SERVICE LETTER 157 PAGE 1 of 7 REV: B

SERVICE LETTER NUMBER 157					
10000 BULKHEADS 8-12, LOWER FLANGE REINFORCEMENT					
BY: MAB	AIRCRAFT	FLOAT MODEL(S):	NOTES: OPTIONAL		
APP: SDW	MAKE/MODEL(S):		COMPLIANCE		
DATE: 5/21/2019		10000			
REV: B	AIR TRACTOR		S/L P/N 1008067		
	AT-802, AT-802A

This service letter applies to Air Tractor AT-802 and AT-802A when equipped with Wipline model 10000 floats (STC SA01795CH).

FIGURE 1: AFFECTED BULKHEAD FLOAT STATION LOCATIONS

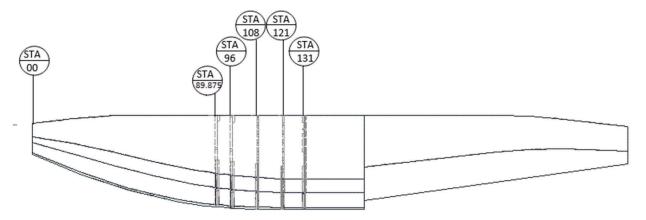
Aircraft equipped with Wipline model 10000 amphibian floats that regularly operate in rough water, may experience cracking of the forward and aft lower bulkhead flanges located in the baggage area of the float as indicated in Figure 1. This service letter and associated kit reinforce the lower bulkhead flanges to reduce probability of cracking as a result of operations in rough water.

- 1) Remove the top deck covers and open baggage hatches to gain access to the affected bulkheads shown in Figure 1. Remove baggage hatch floors to gain access to lower bulkhead flanges.
- 2) If cracks are found in flanges, stop drill as needed.
- 3) After drilling interfering rivets out of existing bulkhead, position the doublers best fit to contour and match drill at each forward and aft lower bulkhead flange.
  - Match drill these rows to existing rivet locations in lower flange and bulkhead face.
  - Add this upper row at 0.5 inch edge distance using the forward doubler, and then match drill into the aft doubler. Match lower row spacing.

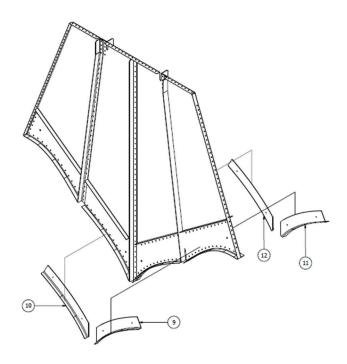
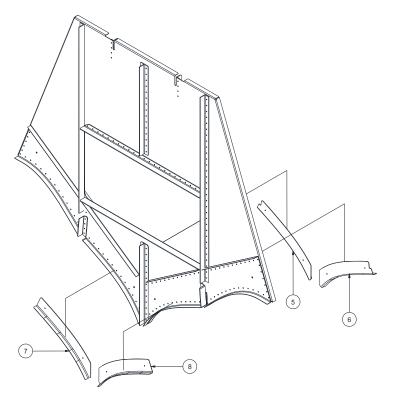
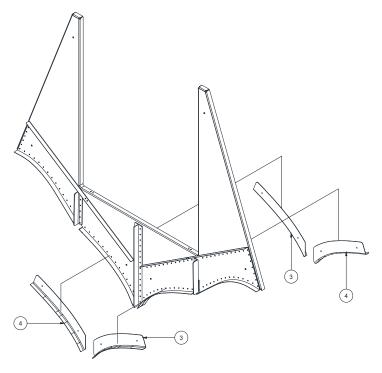
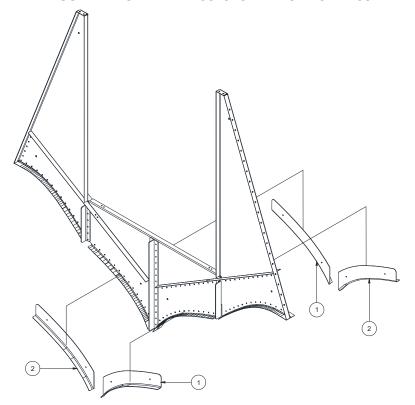
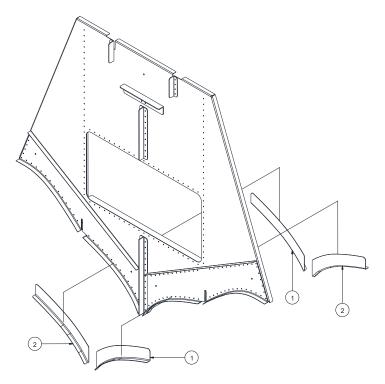
- 4) Deburr all drilled rivet holes in bulkheads and doublers.
- 5) One doubler at a time; apply PR1422 sealant completely to mating faces of doubler, bulkhead, and bottom skin, then rivet appropriate doublers as called out in the Parts List and Figures 2-6 to the forward and aft lower bulkhead flanges and bottom skin using MS20470AD4 rivets, grip as required. Perform this operation at bow bulkheads indicated in Figure 1. Drive rivets while sealant is wet.
- 6) Wipe away excess wet sealant after riveting.
- 7) Replace baggage hatch floors and reinstall top deck covers with new seals.
- 8) Water check floats
